Service Bulletin

Bulletin No. 2004-63R2 CMD 2004-03

Crankshaft Pulley Slip

CMD	2.8 ES and EI 200	88010026 to 88010550
CMD	2.8 ES and EI 170	88005200 to 88005238

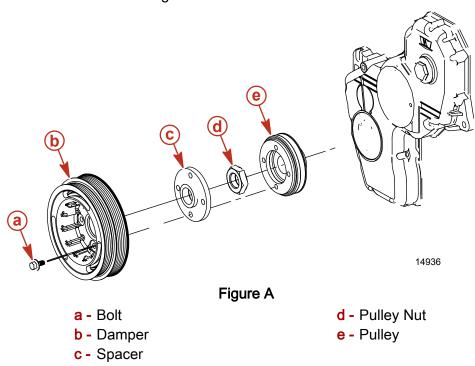
On a specific number of 2.8 ES and EI engines, the pulley nut may not have sufficient torque from the factory, therefore the pulley may slip under normal operation.

- 1. Remove the starter motor and lock the crankshaft from the flywheel housing using holding tool 91- 895472 or equivalent.
- 2. Refer to "Figure A." Remove the belt and the four bolts attaching the damper and spacer to pulley. Remove spacer.
- 3. Remove the left handed thread pulley nut.
- 4. Install the pulley nut with Loctite Moly Paste (Molybdenum Disulfide Grease) on the threads and pulley contact surface.

5. Torque the pulley nut.

Description	Nm	lb. in.	lb. ft.
Pulley nut	400		295

6. Install the spacer and damper with four bolts. Torque the damper bolts.

Description	Nm	lb. in.	lb. ft.
Damper bolts	25		18.5
